SUBJECT: AMENDMENT NO. 126 TO FACILITY OPERATING LICENSE NO. DPR-50

THREE MILE ISLAND NUCLEAR STATION, UNIT NO. 1

AMENDMENT TO FACILITY OPERATING LICENSE

Amendment No. 126
License No. DPR-50

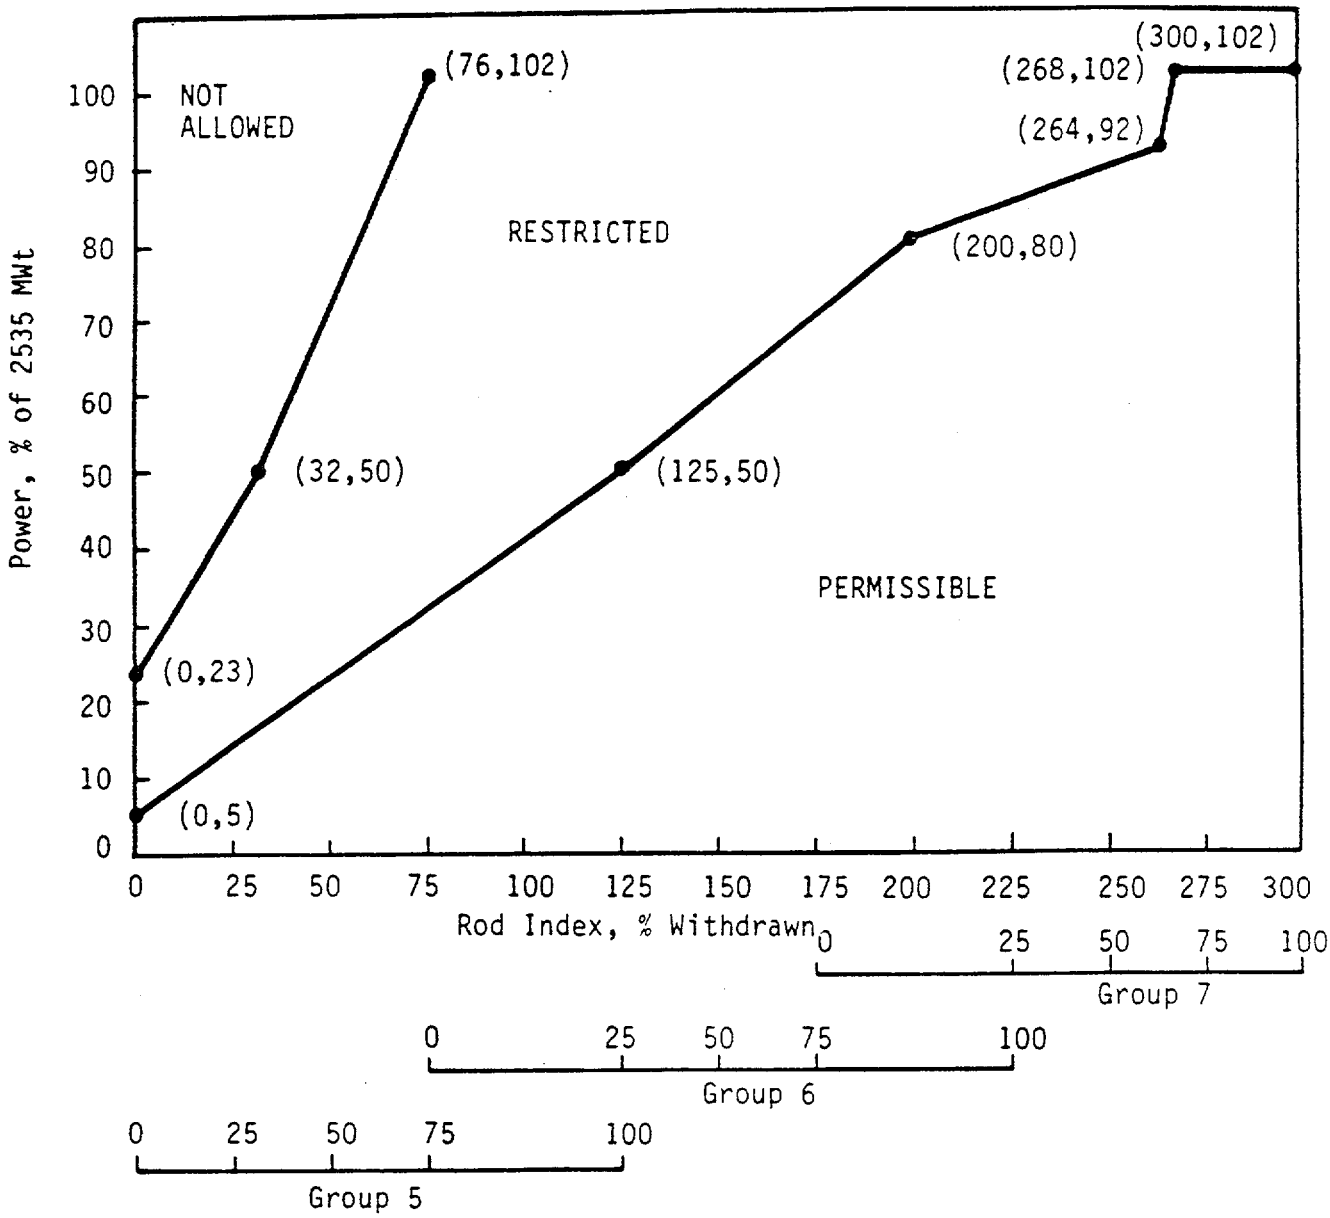
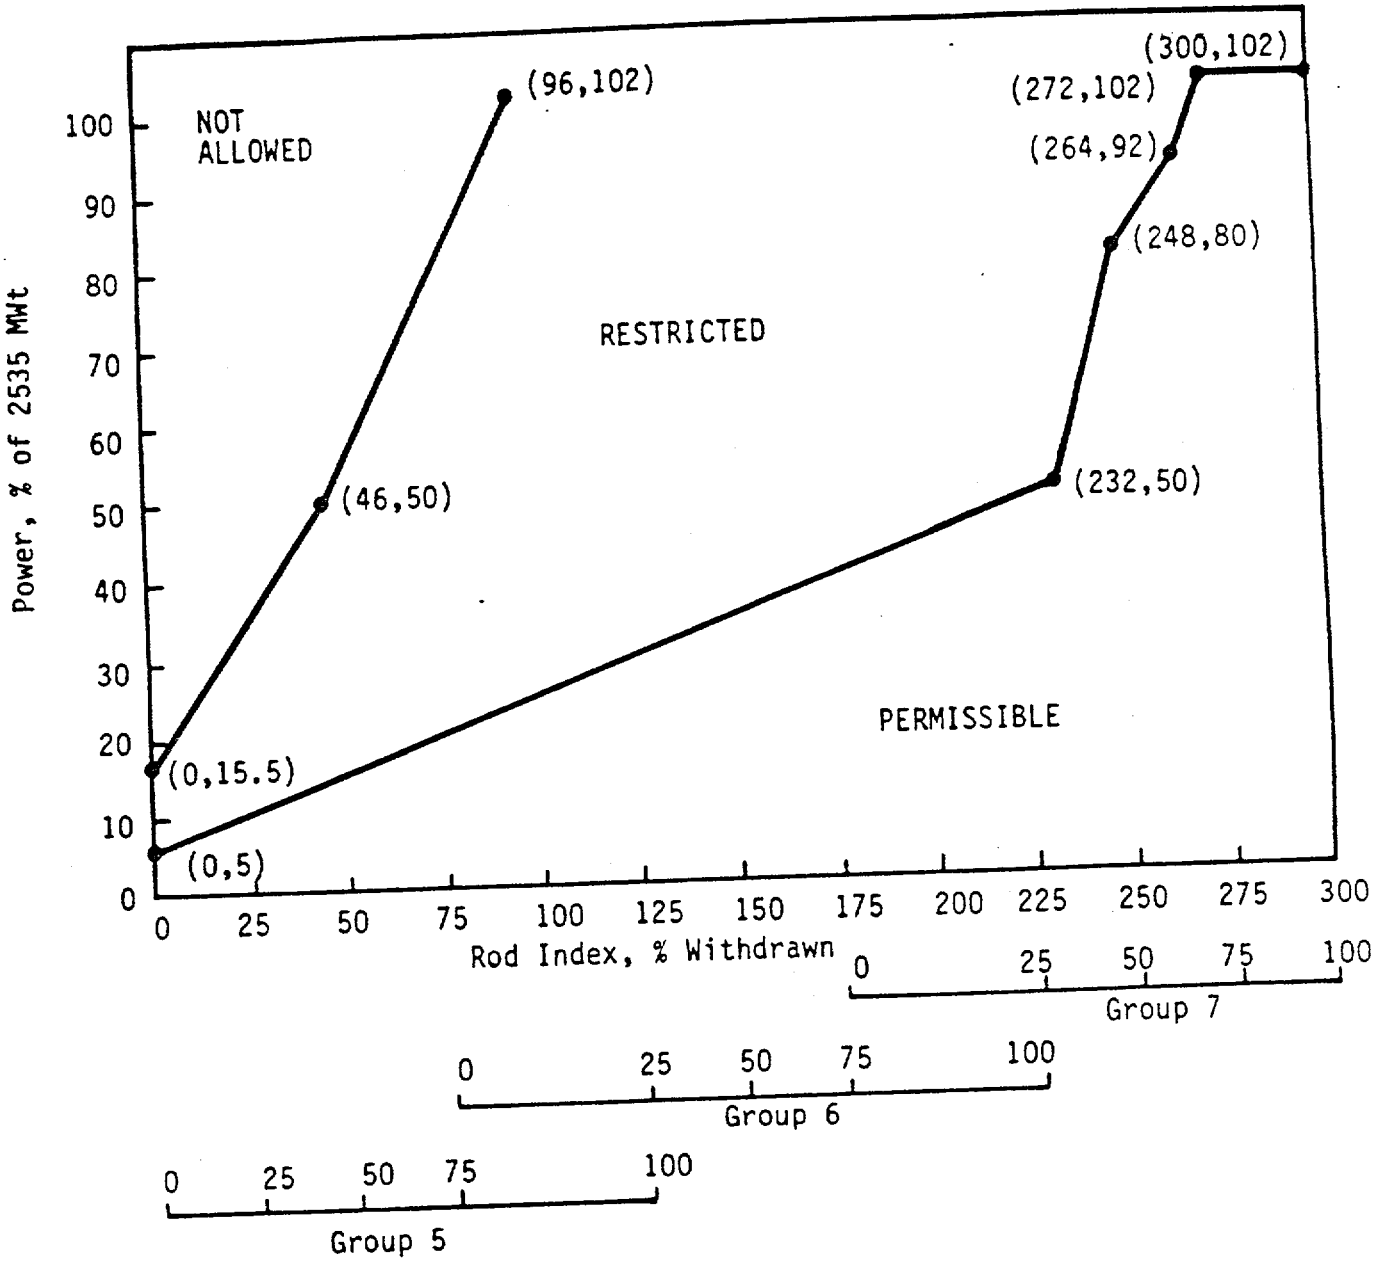
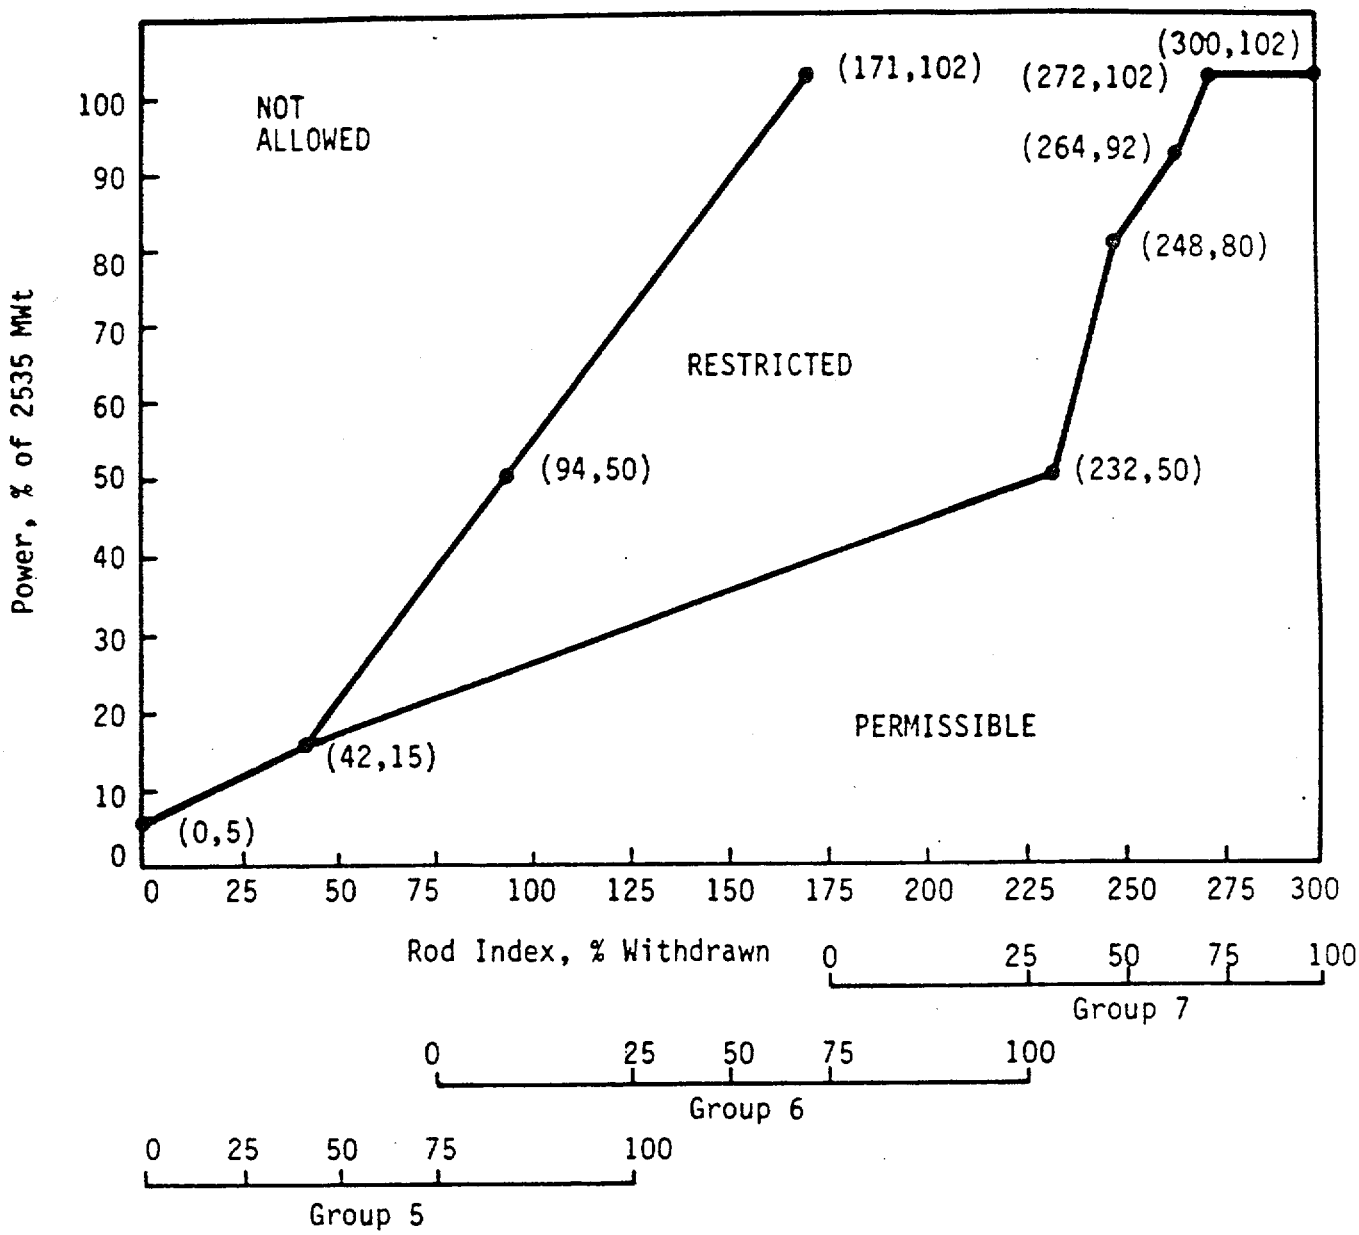
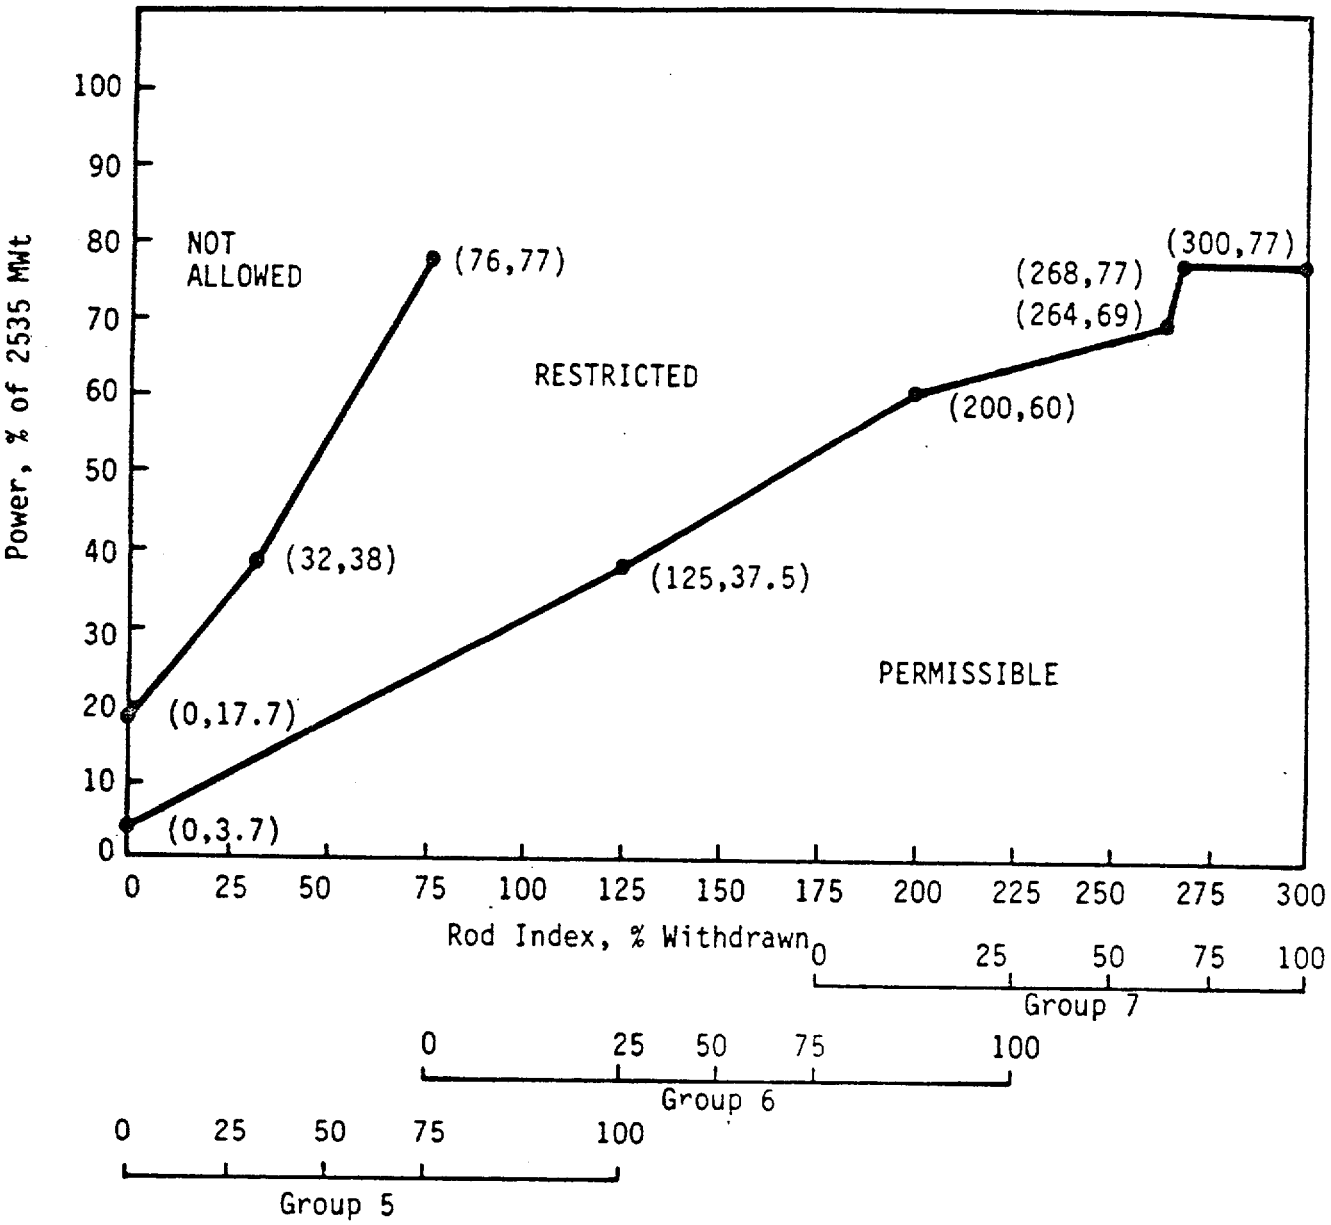
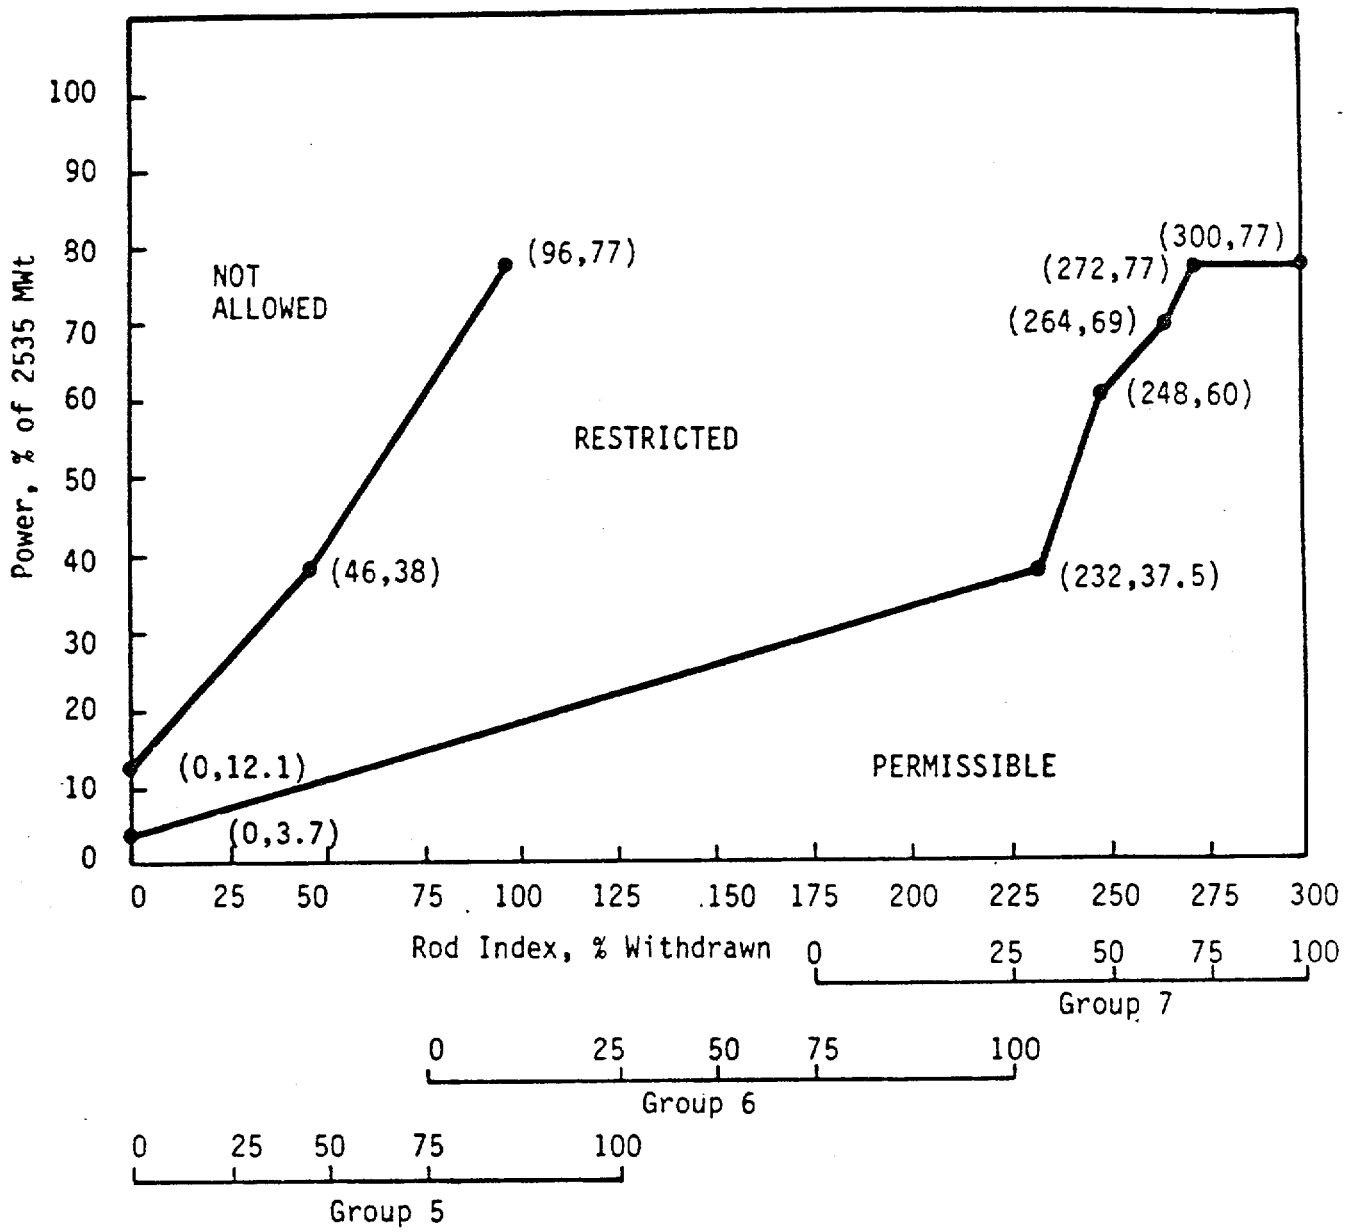
New control rod insertion limits (Figure 3.5-2A through Figure 3.5-2I) are provided for 4, 3 and 2 pump operation, as well as a function of burnup interval. These Figures are acceptable since they are based on the Cycle 6 safety analysis discussed previously.
